Figure 1

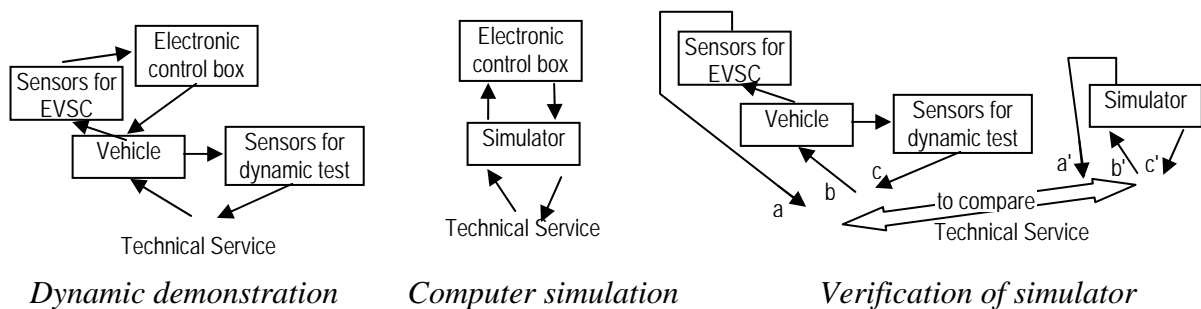
simulation model against a practical test the real vehicle behaviour and the real sensor characteristics

Reason for the proposed change : In the case of a computer simulation, not only the electronic control box but also the performance of the sensors used by the stability system have to be considered (figure 1) in real world the values used by ESC are not the exact ones but the values measured by the sensors.

Verification of simulator means that for a given input $b=b'$, the differences $\Delta a=a'-a$ and $\Delta c=c'-c$ are below a given threshold (see §4.2 of Appendix 1).
